E8801A-01D

S E R V I C E N O T E

E8801A PNA Series RF Network Analyzers

Serial Numbers: 00000000 thru 46999999

Figure 1

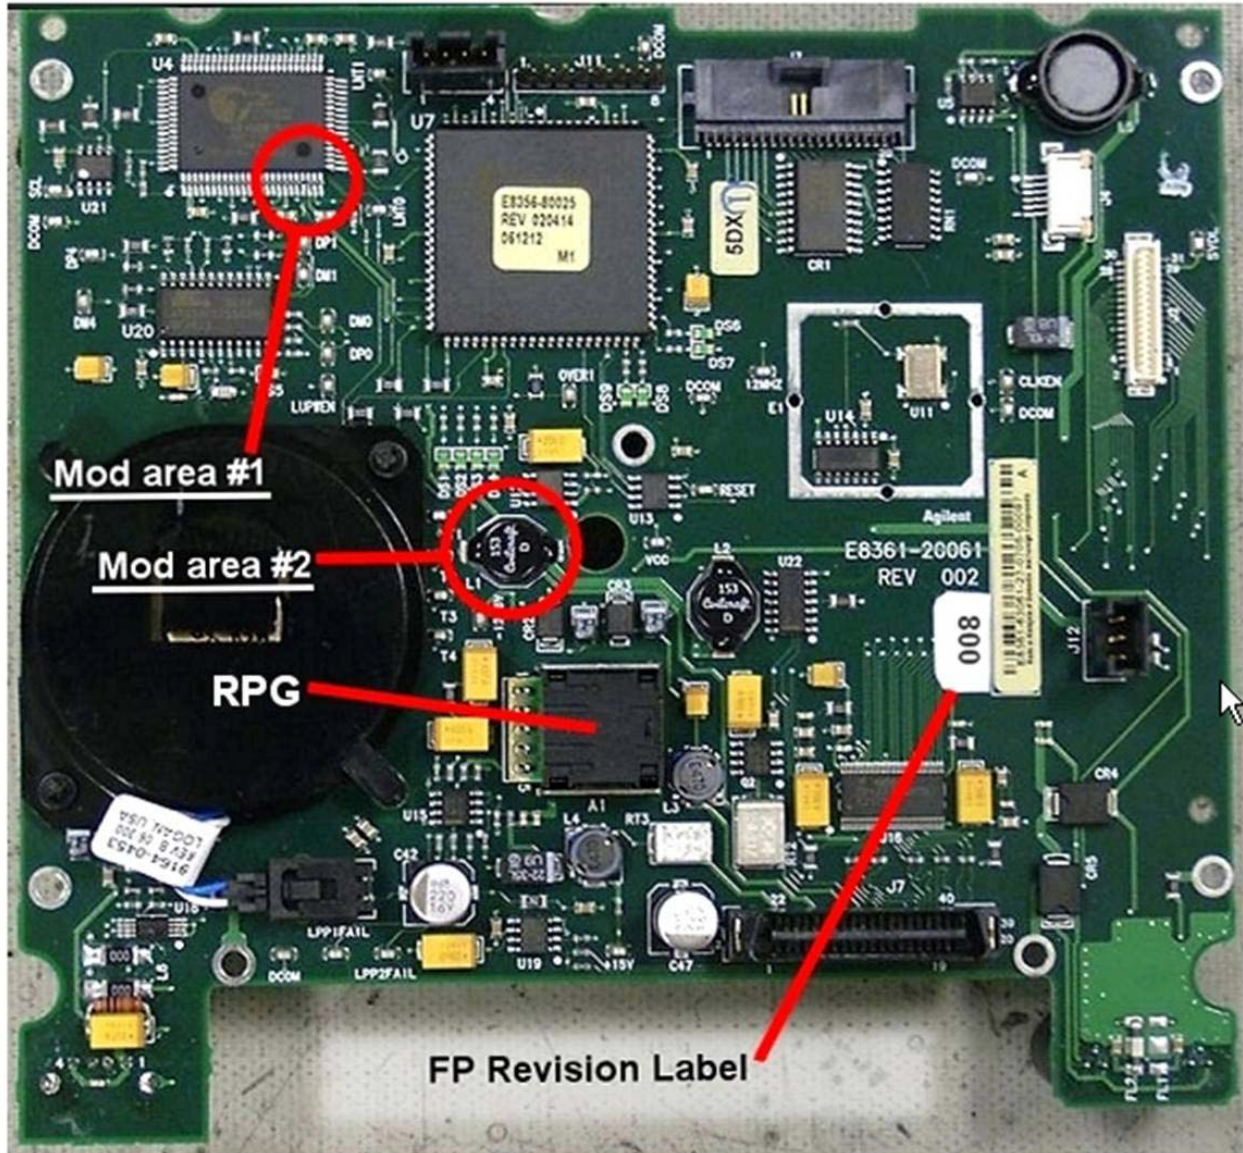
Refer to Figure 1 for the two modification areas to be addressed. Note that while this picture happens to show the FPI board completely removed from the front frame assembly, this is not necessary to perform the required modifications.

- Modification #1 consists of shorting two pins of U4 together with a small amount of solder.
- Modification #2 consist of removing L1.

Figure 2

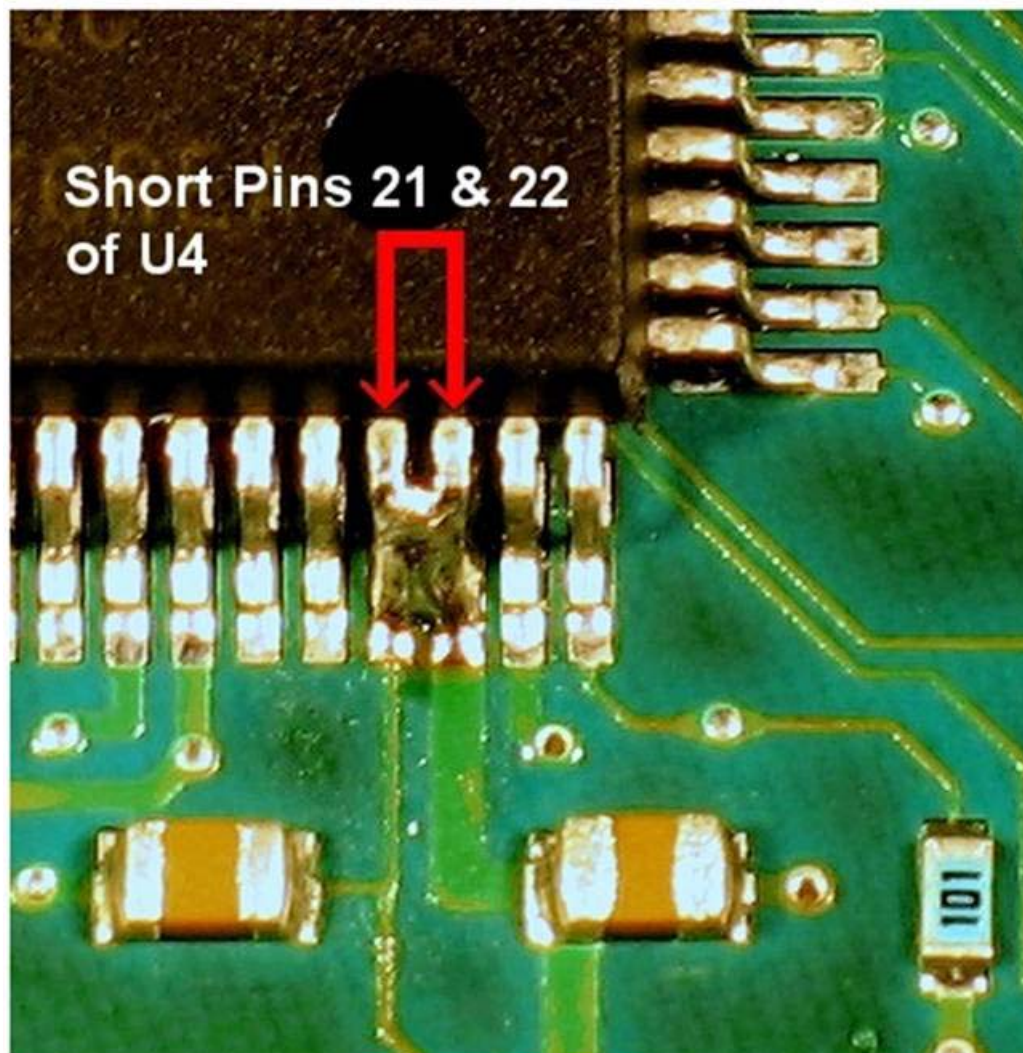
Carefully solder pins 21 and 22 together on U4. Refer to Figure 2 for the exact location. Use care so that no other pins are shorted. Use of a very fine tip soldering iron is recommended and a large work-task magnifying glass is very helpful.

Unsolder and completely remove the black surface mount inductor L1 from the front panel assembly board. This is no longer needed and can be discarded.
